Re: BCA Assessment Report – 4 Pusan Place, Belrose

This statement provides a Building Code of Australia 2019 (BCA) Assessment for submission with the Development Application / Building Information Certificate Application to be lodged with Northern Beaches Council in relation to works associated with the detached building partially constructed without approval that is proposed to be used as a Secondary Dwelling at the above premises. This is in response to Council's Notice of Intention to give a Development Control Order dated 26 August 2020.

Figure 1 – Detached Proposed Secondary Dwelling

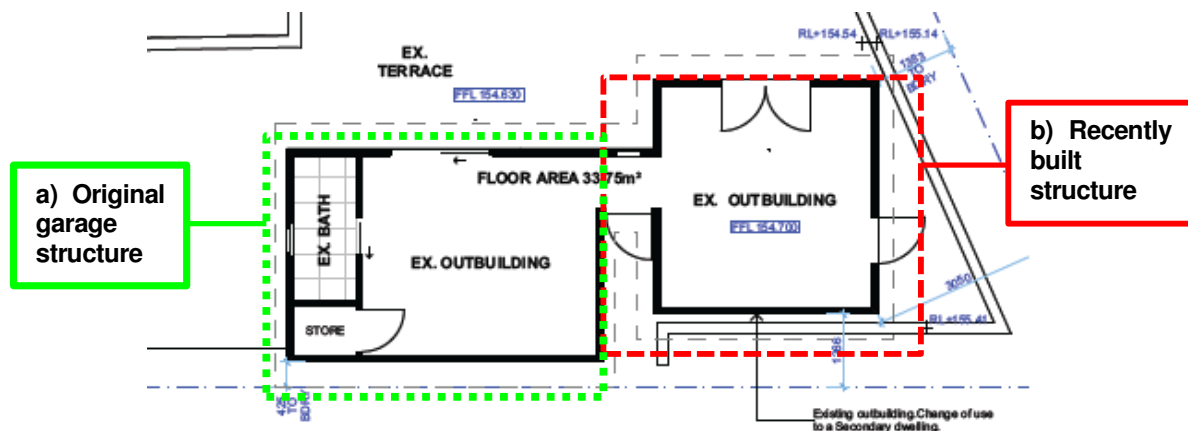
The subject detached building is assessed under the Building Code of Australia 2019 [Volume 2] (BCA). The proposed Secondary Dwelling is separate from the main dwelling. This detached Secondary Dwelling is in 2 components, being the front portion (i.e. pre-existing garage) plus the recently completed building works to the rear comprising bedroom and hall as shown in Figure 1 above.

The building works the subject of this Report is of concrete slab on ground with timber frame lightweight external cladding and metal roof sheeting. The building is in 2 parts as shown in Figure 1 above that are as follows: -

Other than minor modifications it is assumed the pre-existing structure is as originally approved by Council. The changes to the pre-existing structure and the new works forming the rear portion of the proposed Secondary Dwelling require verification from a Structural Engineer to confirm these building elements are structural adequate to satisfy the relevant Australian Standards.

The southern external wall of the front (pre-existing) portion of the proposed Secondary Dwelling is less than 900mm from the side boundary (i.e. approximately 425mm) and requires upgrade with materials to achieve an FRL of 60/60/60 measured from outside the building. The roof, eave, fascia and gutter to this portion of the building are non-combustible, therefore satisfy the BCA and need not be upgraded.

- b) That the front (pre-existing) portion of the proposed Secondary Dwelling as shown in Figure 1 of this Report, be upgraded so that the southern external walls less than 900mm from the side boundary be upgraded with constructed having an FRL of 60/60/60 measured externally.**

- a) ***That the works undertaken be reviewed for structural adequacy to include: -***

- ***Modifications to walls of pre-existing (original garage) that is the front portion of the proposed secondary dwelling, and***
- ***New floor slab to rear portion of proposed secondary dwelling, and***
- ***New wall and roof timber framework to rear portion of proposed secondary dwelling.***

Certification is to be obtained from a structural engineer to confirm these various building elements are structurally adequate to satisfy the relevant Australian Standards (e.g. AS/NZS1170.0-2002, AS/NZS1170.1-2002, AS/NZS1170.2-2011, AS1170.4-2007, AS1684.2-2010, AS1684.4-2010, AS2870-2011).
